This sheet supersedes sheet 290. 3-24-60.

PIERS
BRIDGE NO. LAK-I-0276
UNDER MAPLE GROVE ROAD

LAKE COUNTY STA. 145+98.94

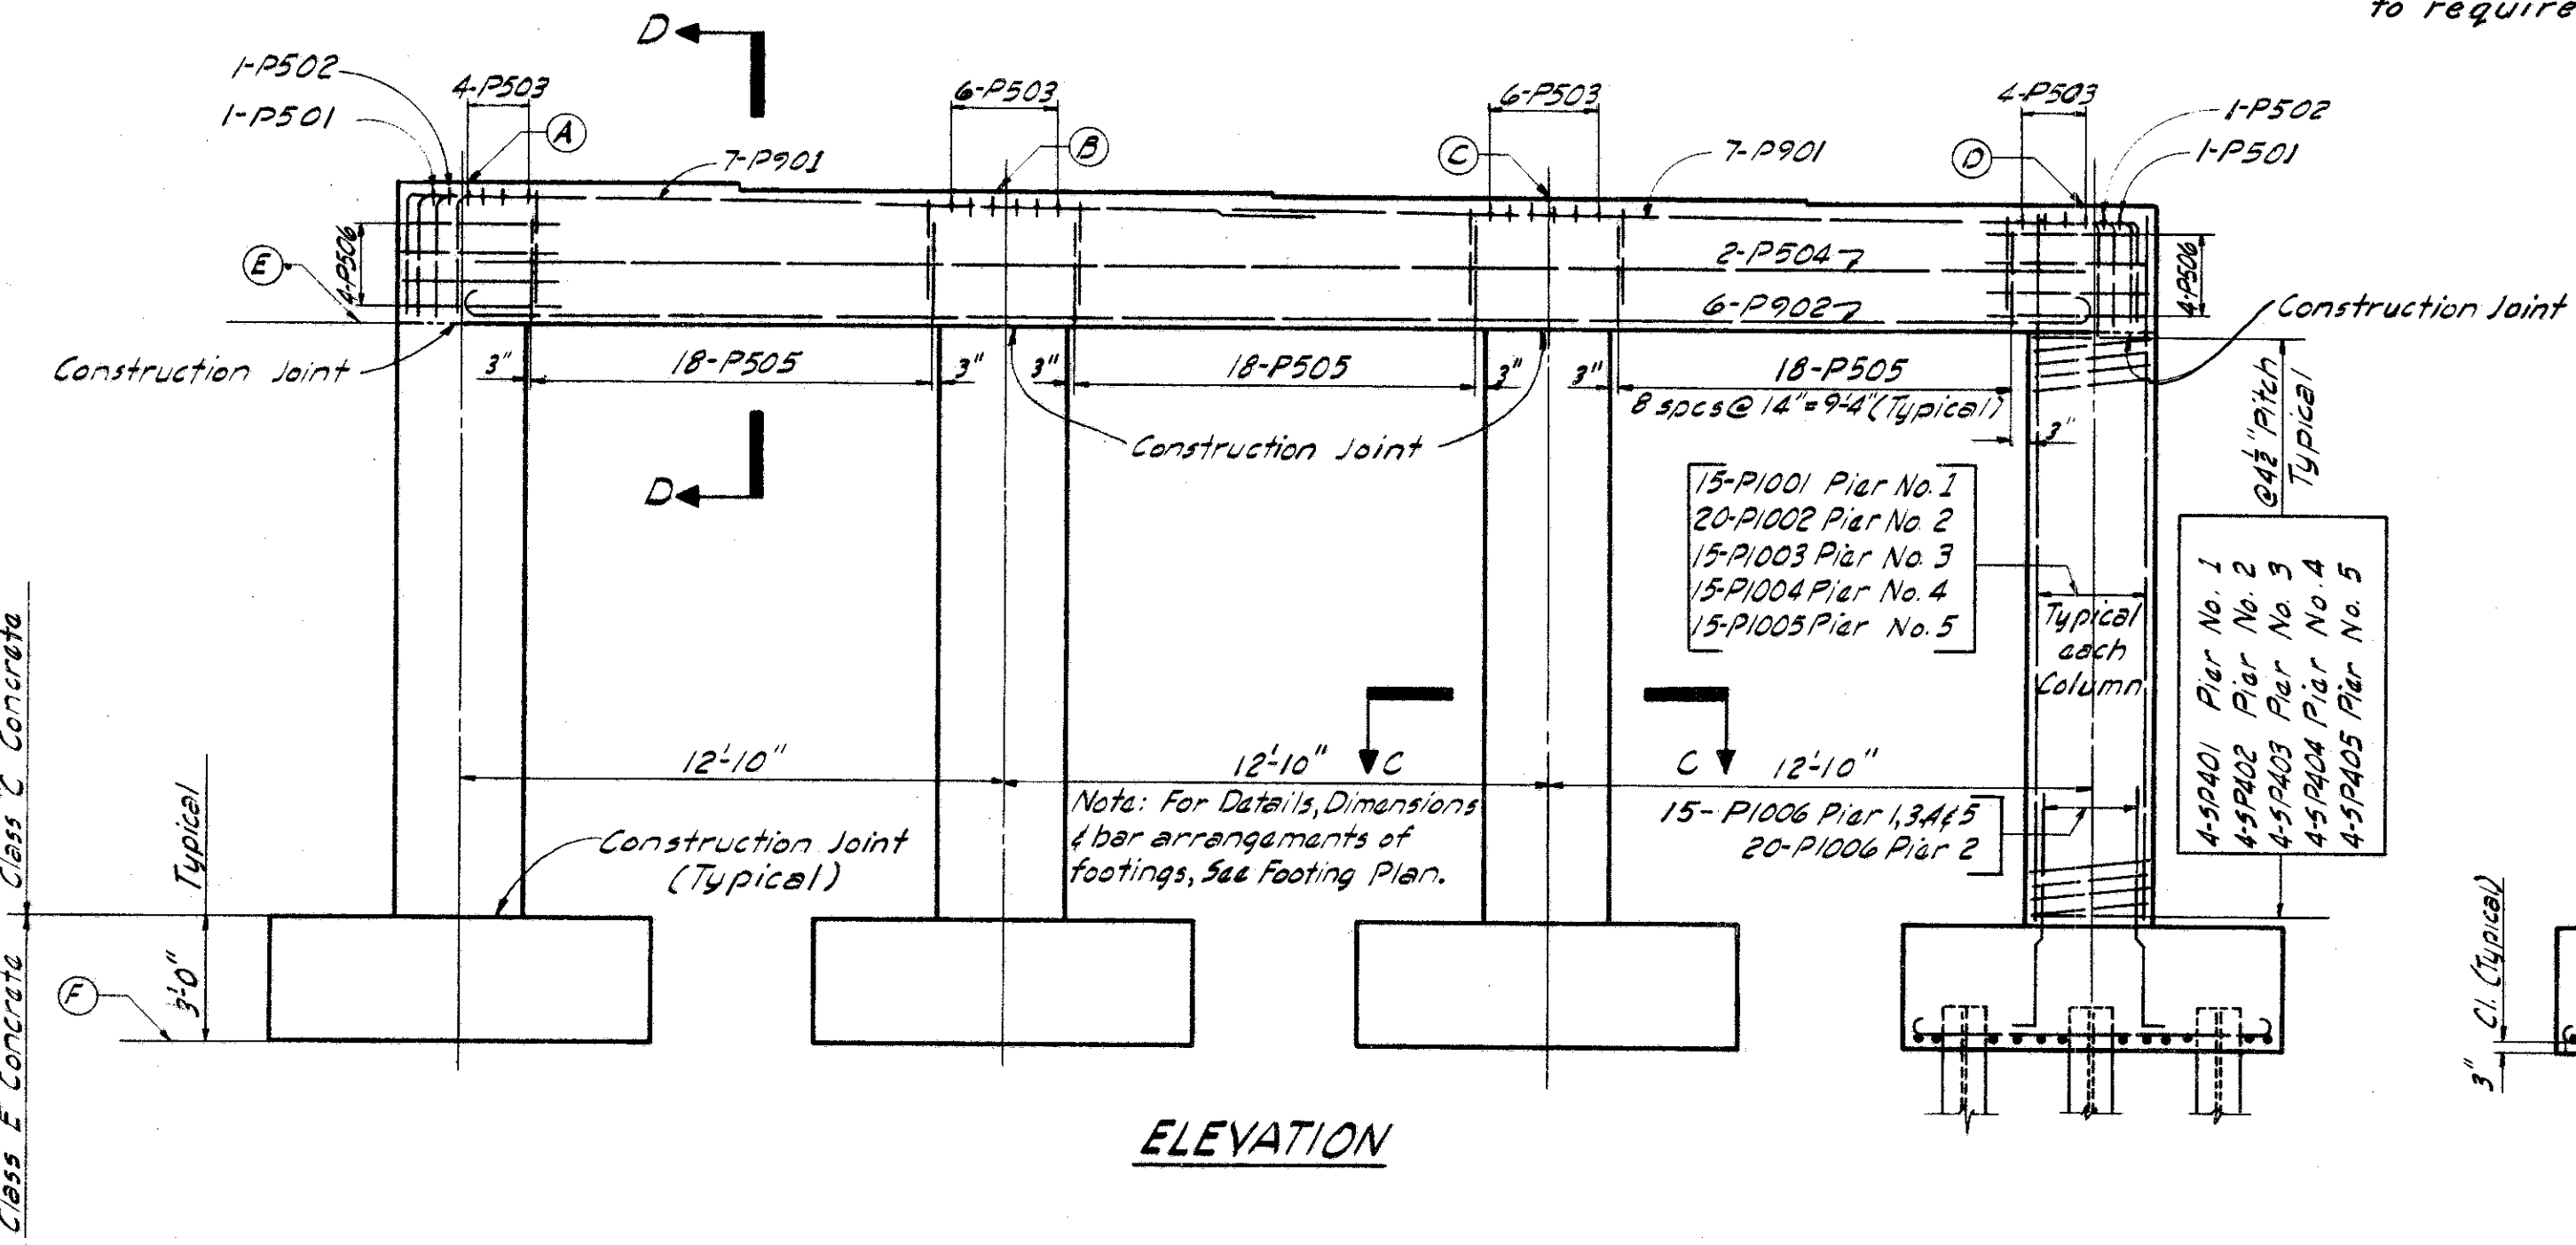
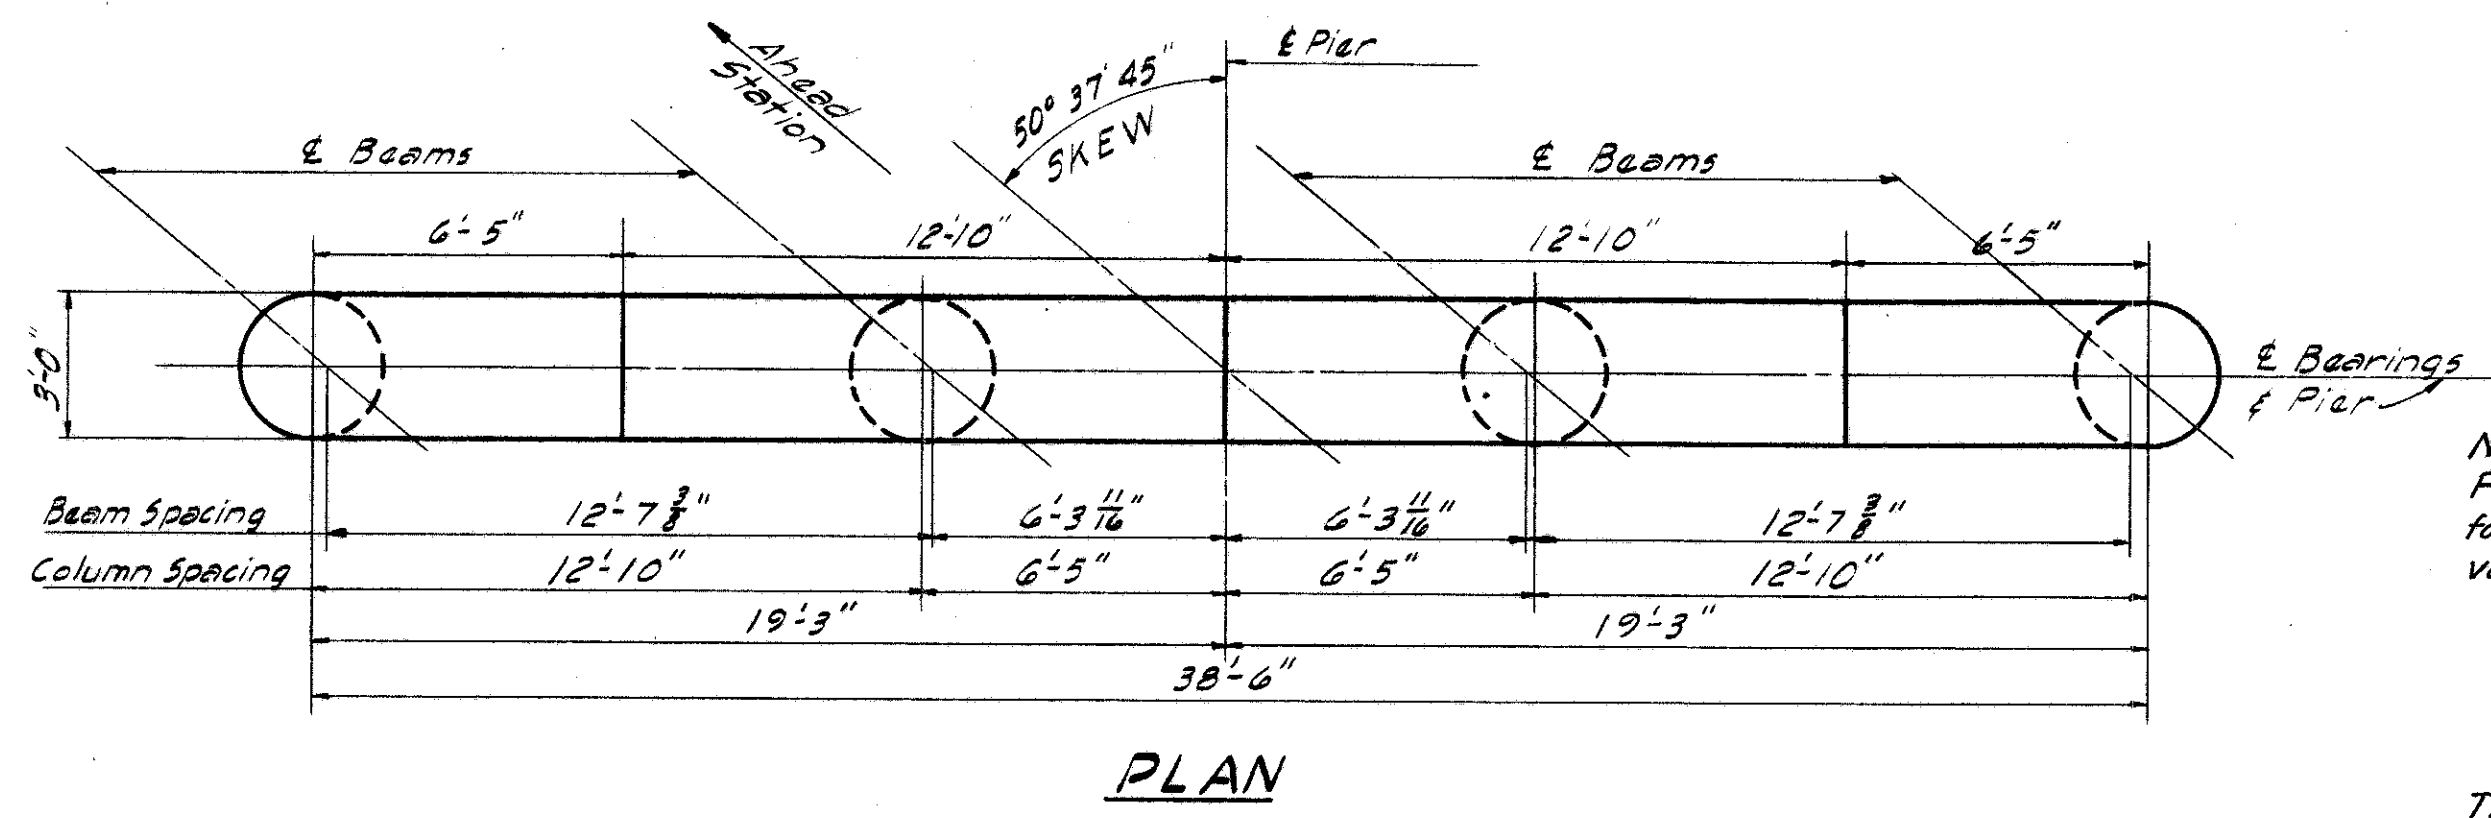
NOTE:
For revised pier height provide the following reinforcing bars to lap with vertical column bars:
Pier No. 1: 60-#10 x 4'-3"
Pier No. 2: 80-#10 x 4'-7"
Pier No. 3: 60-#10 x 4'-7"
Pier No. 4: 60-#10 x 4'-4"
Pier No. 5: 60-#10 x 3'-11"
The length of spiral bars to be increased to required change in height.
